DOCUMENT NUMBER: 17-00177 **RELATED DOCUMENTS:**

# 9003/9003B Scrambler

This Service Bulletin announces corrective action required to all 9003 and 9003B scramblers prior to serial number B0343. The modifications described below should be performed whether the symptoms exist or not.

Figure 2: location of Shottky diode and Reset IC

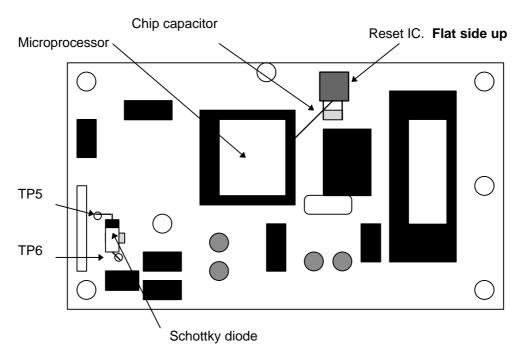
☐ Locate TP5 and TP6. Refer to Figure 2.

- ☐ Fit the Schottky diode (1N5817) into TP5 and TP6 as shown in Figure 2.
- □ Solder and trim the leads.
- ☐ Fit the Reset IC as shown in Figure 2. Ensure the flat side is uppermost.
- ☐ Trim and solder the two outer leads across the chip capacitor as shown. Be careful not to dislodge the chip capacitor.
- ☐ Trim and solder the centre lead to Pin 17 of the Microprocessor IC. Ensure that no short circuits exist.

Pin 17 is the 4th Pin down from the top right corner (as viewed in Figure 2). Refer to Figure 3.
